Seabrook Station

"Response to Requests for Additional Information Pertaining to
the 2nd Ten-Year Interval Inservice Test Program Plan Relief Requests"

Enclosure 1 to NYN-00070

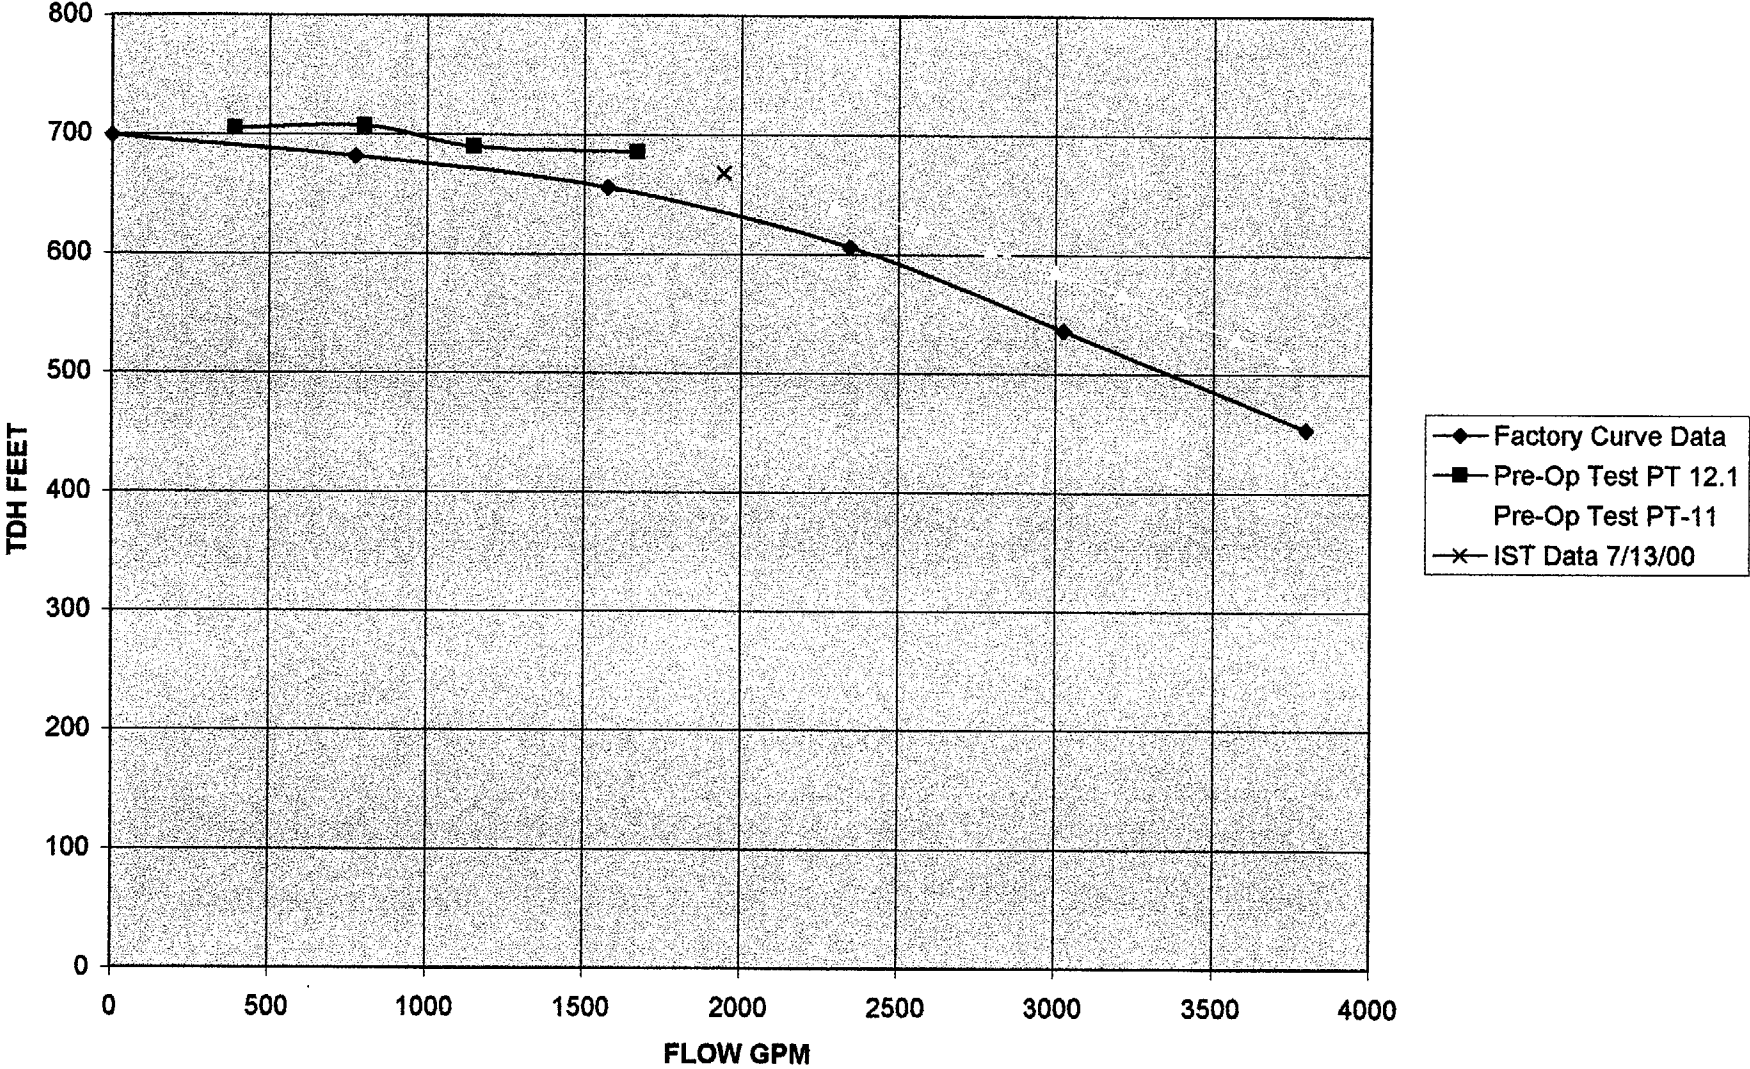
1. What type of diagnostic equipment and techniques will be used to measure stroke time?

North Atlantic currently tests or has tested certain solenoid-operated valves by the use of strip chart recorders measuring the current applied to the coil. This method has proven to be a more accurate indicator of actual valve stroke time and performance than measurement of stroke time with a stopwatch.

The valve vendor has recommended the above described time trace method as the way of monitoring the valve's performance. The valve vendor has indicated that stroke time measurements using the reed switches are not indicative of actual disc movement. It is only a go/no-go test that provides little information as it measures reed switch actuation not actual disc

position. The time trace method, if performed with the same test equipment demonstrates actual valve stem movement.

CBS Pump 9B Performance Curves

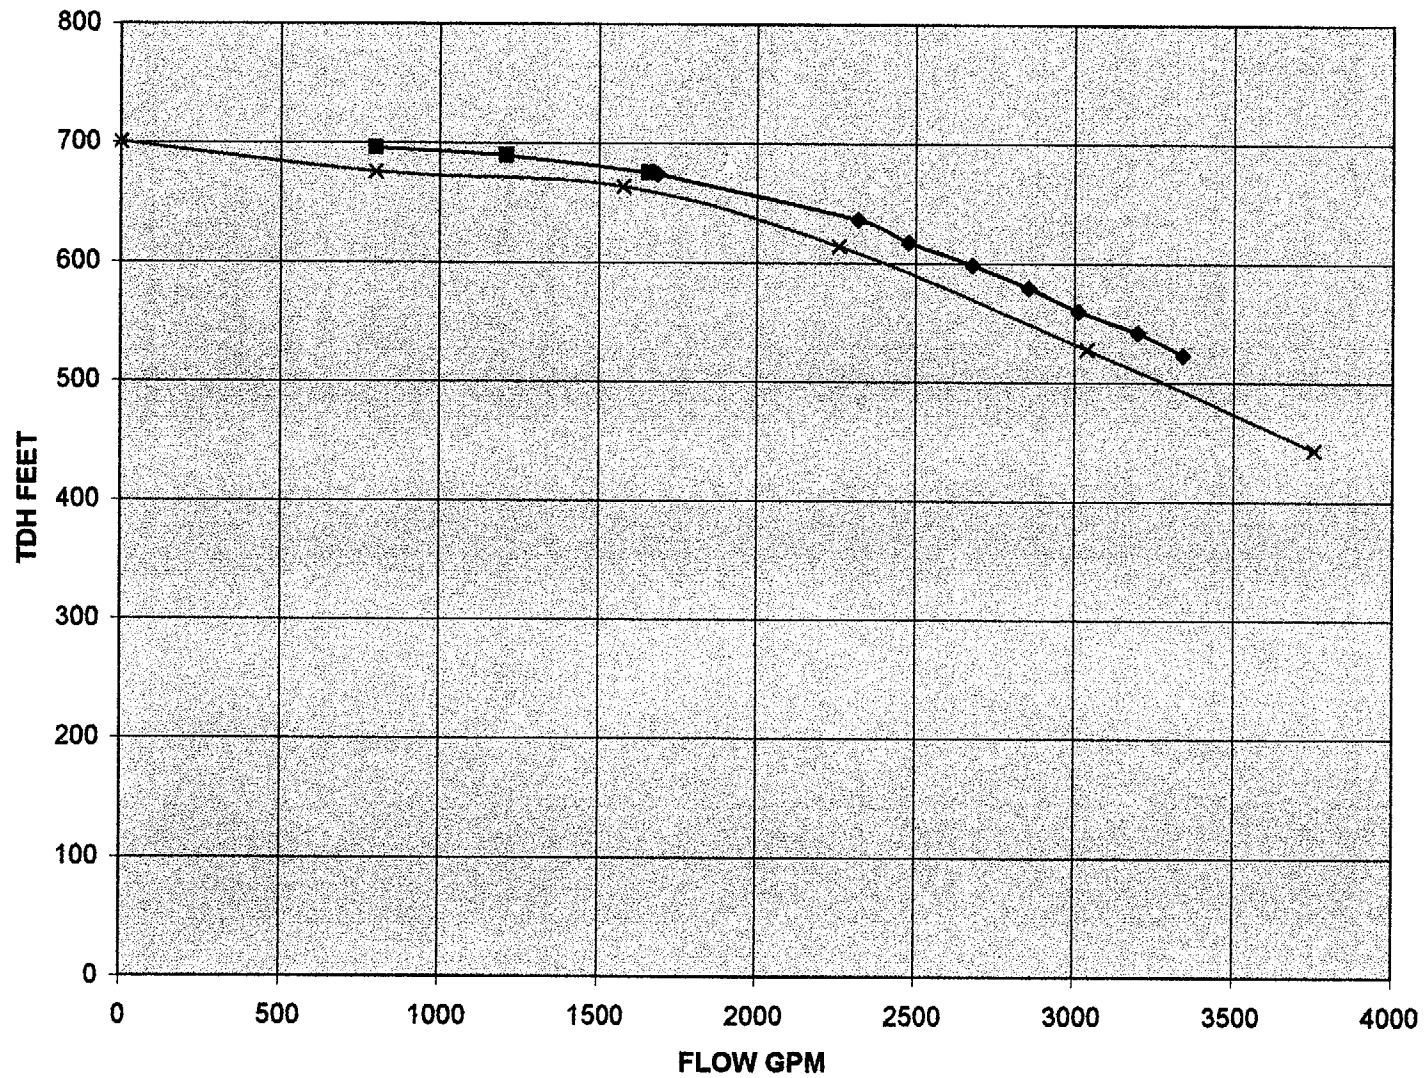
2. Please provide data to demonstrate that the proposed testing meets the intent of the testing required by ISTB 4.3.e.1.

The performance curves for both Containment Building Spray pumps are provided in Enclosure 2. Both IST points identified were the latest taken and are representative of the historical IST data.
